Access Compliance Report

Public Rights-of-Way

(Curb Ramps)

Intersection ID: 7094	Main Street: EQUIPMENT_DR	Cross Street: W_SUGAR_CREEK_RD	Location: E
ADA ID: 2BAD19F0EDAC	Ramp Type: Perp	Initial Pass/Fail: Fail	Overall Compliance: No
Severity Score: 12.5			
Codes/Mitigation Info/Possible Solution		Field Measurements/Component Compliance

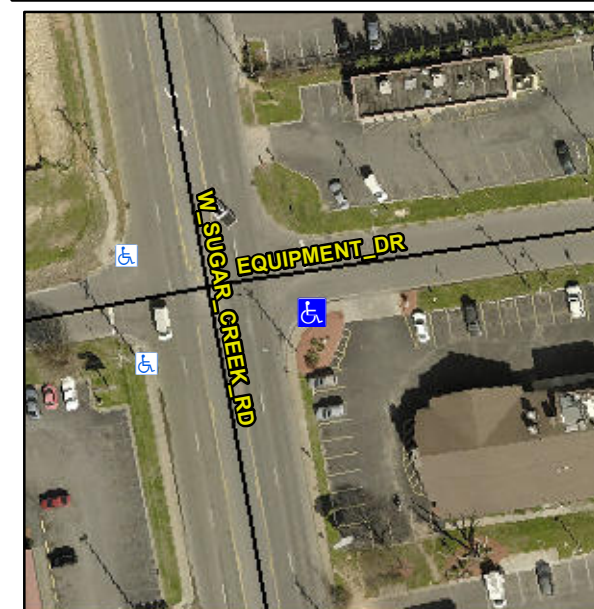
Not Found, R304.2.2

Compliance	Description	Data	Compliance	Description	Data
N/A	Ramp Length (in)	56.5	No	Ramp Slope (%)	11.5
Yes	Ramp Width (in)	54.0	Yes	Ramp XSlope (%)	1.6
N/A	Flare Type LT	N/A	N/A	Flare Type RT	N/A
N/A	Flare Slope LT (%)	N/A	N/A	Flare Slope RT (%)	N/A
N/A	Flare Traversable LT?	N/A	N/A	Flare Traversable RT?	N/A
N/A	Landing Length (in)	N/A	N/A	DWS Provided?	N/A
N/A	Landing Width (in)	N/A	N/A	DWS Contrast?	N/A
N/A	Landing Slope (%)	N/A	N/A	DWS Length (in)	N/A
N/A	Landing X Slope (%)	N/A	N/A	DWS Full Width?	N/A
N/A	Landing Curb? (Y/N)	N/A	N/A	DWS Offset (in)	N/A
N/A	Shared Landing?	N/A			
N/A	Gutter Ponding?	N/A	N/A	Gutter Slope (%)	N/A
N/A	Gutter Lip Ht (in)	N/A	N/A	Gutter X Slope (%)	N/A
N/A	Painted X Walk1?	No	N/A	Painted X Walk2?	N/A
	X Walk 1 Direction	To N		X Walk 2 Direction	N/A
N/A	X Walk 1 Width (in)	N/A	N/A	X Walk 2 Width (in)	N/A
	X Walk 1 Slope (%)	2.7		X Walk 2 Slope (%)	N/A
	X Walk 1 X Slope (%)	1.4		X Walk 2 X Slope (%)	N/A

Remove & Replace Entire Ramp.
